ORIGINATION FORM

Proposed Revisions to a Standard Plans Index
(Please provide all information – Incomplete forms will be returned)

Index Number: **515**
Sheet Number (s): 5 of 7
Index Title: Turnouts and Driveways

Sheet 5: Changed the 5' pavement at graded connections callout and note.

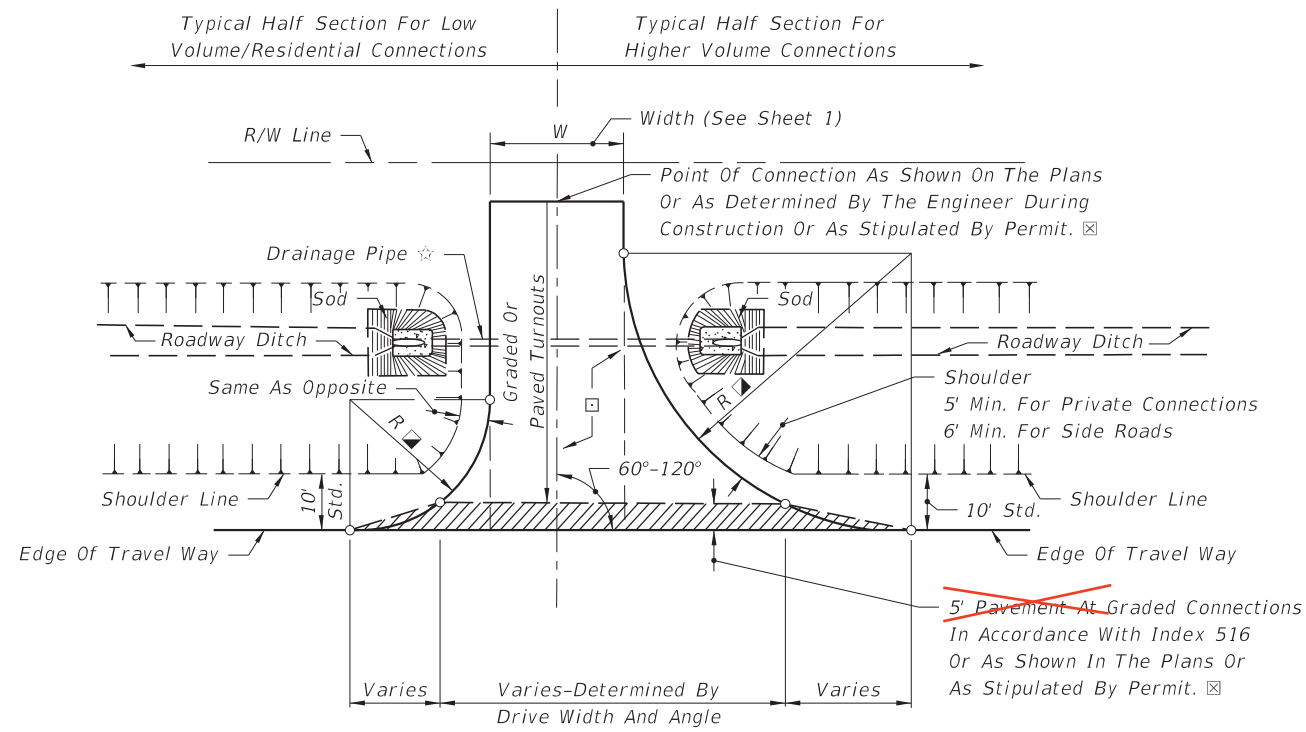
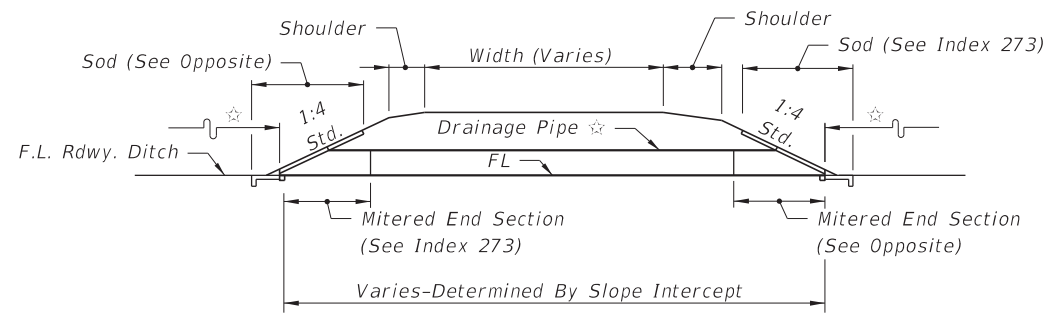
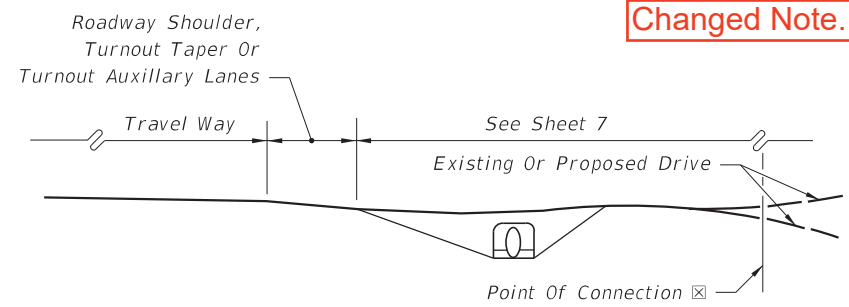
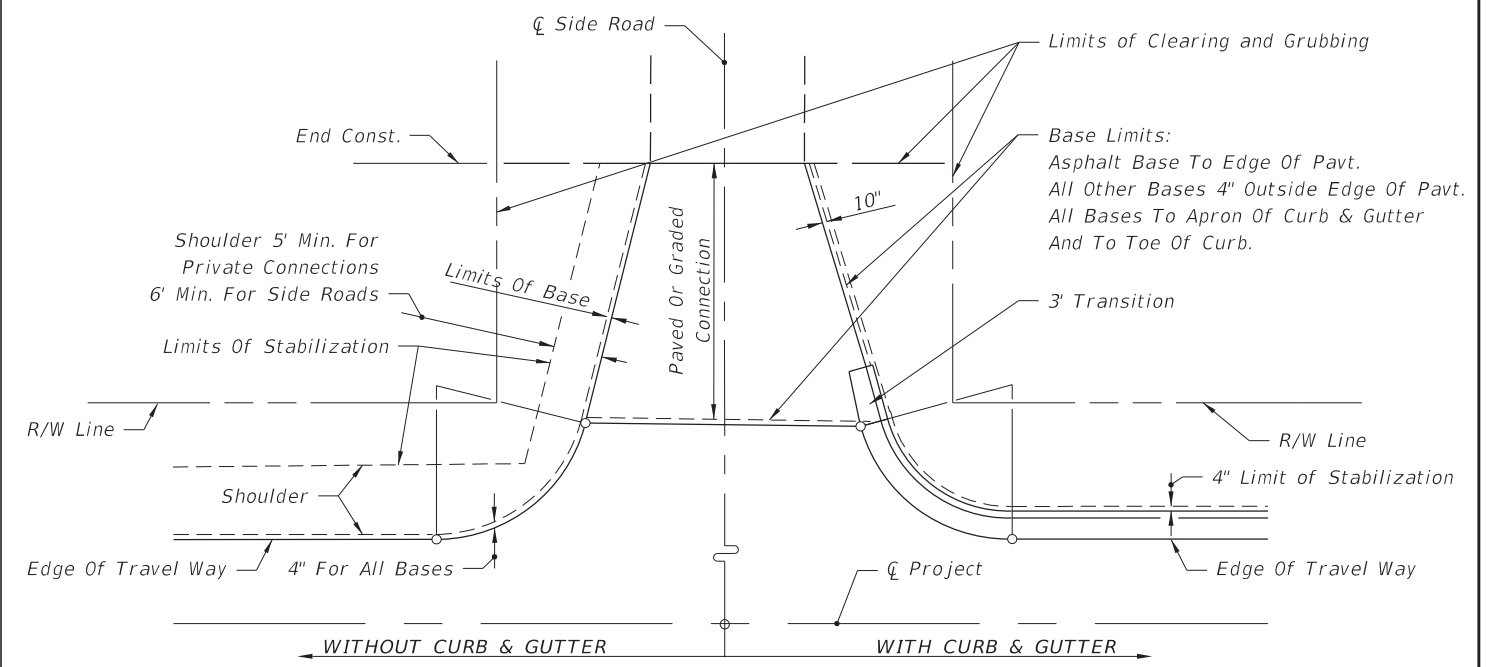
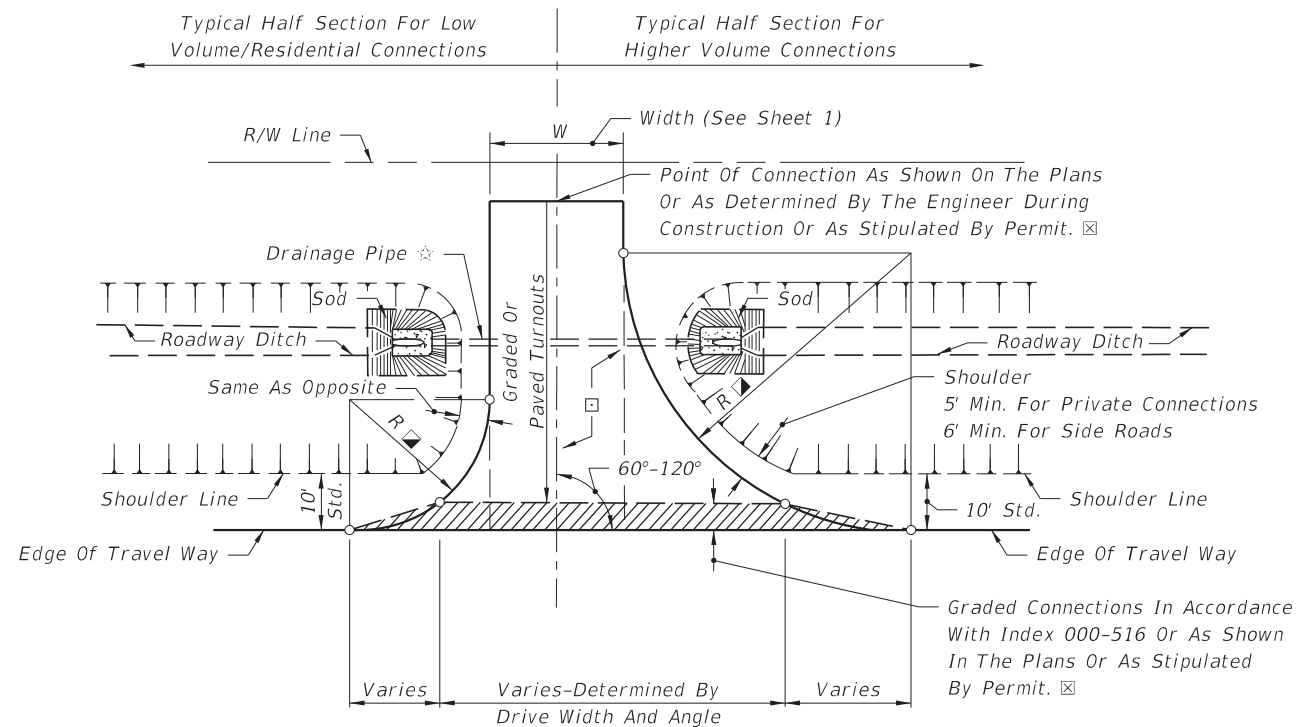
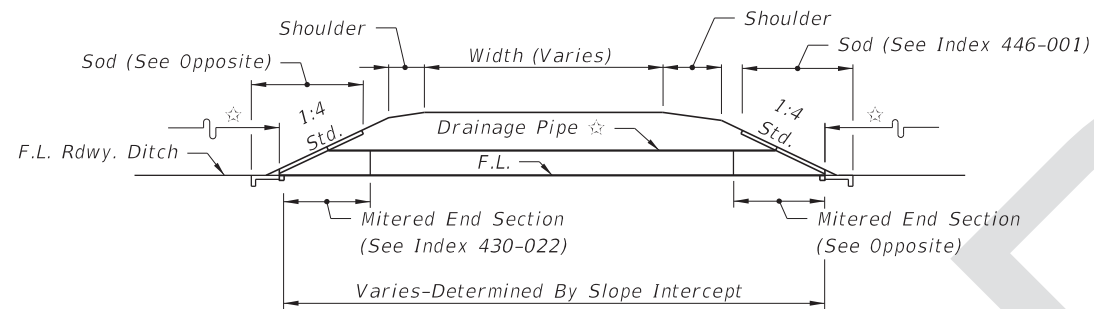
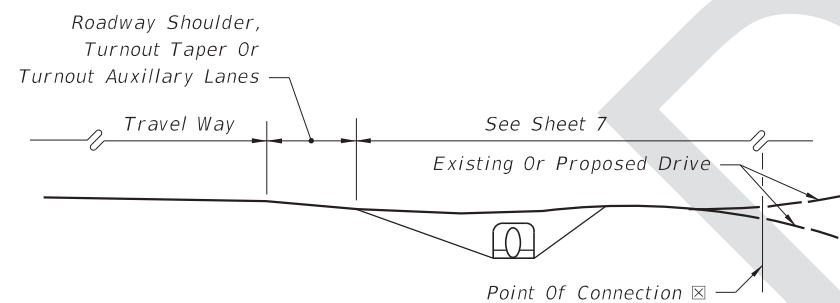
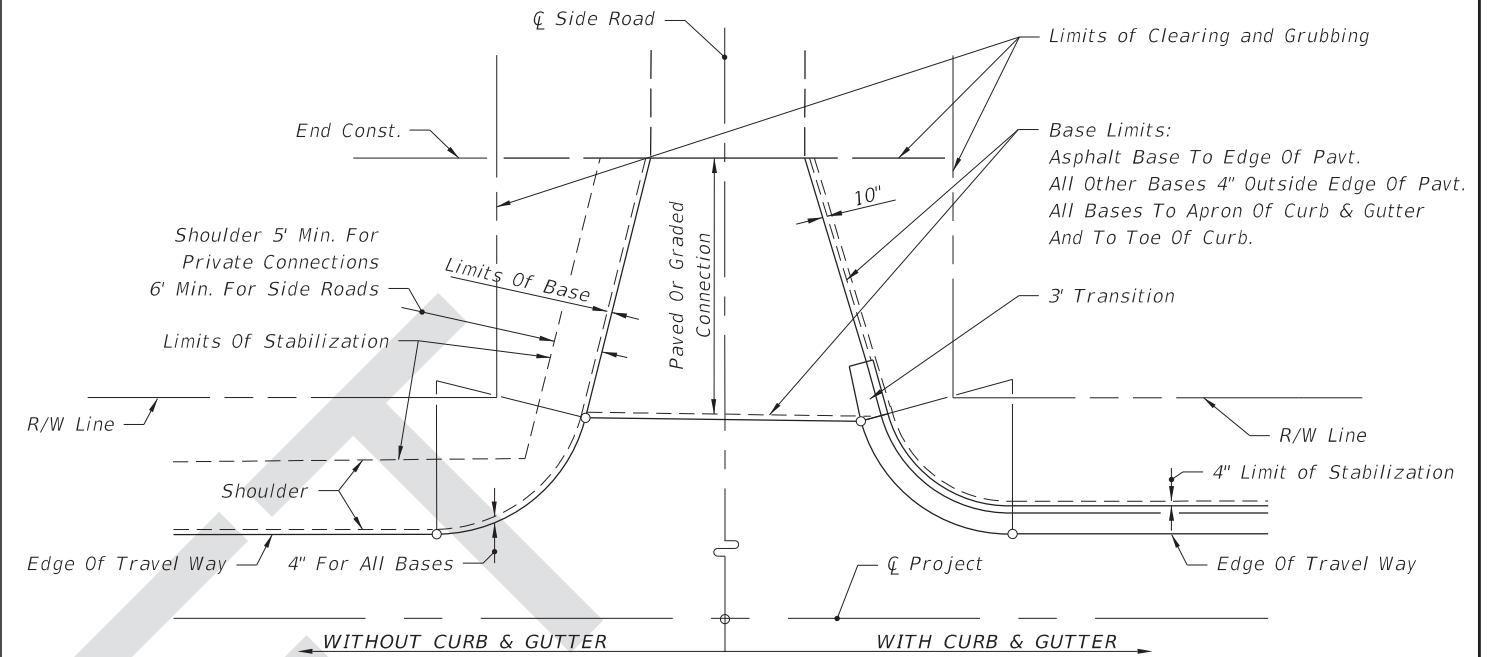
Updated to work with changes make to Index 516.

- ☒ The 5' pavement at graded connections is not required where there is paved shoulder 4' or more in width. The 5' pavement requirement may be waived for connections serving one or two homes or field entrances with less than 20 trips per day, or 5 trips per hour as approved by permit or by the Engineer, or when not itemized in the plans.
Paved turnouts shall be constructed for all paved connecting facilities. The connecting point will be determined by the Engineer.

Changed Note.

☒ The turnout pavement requirement at graded connections may be waived for connections serving one or two homes or field entrances with less than 20 trips per day, or 5 trips per hour as approved by permit or by the Engineer, or when not itemized in the plans.
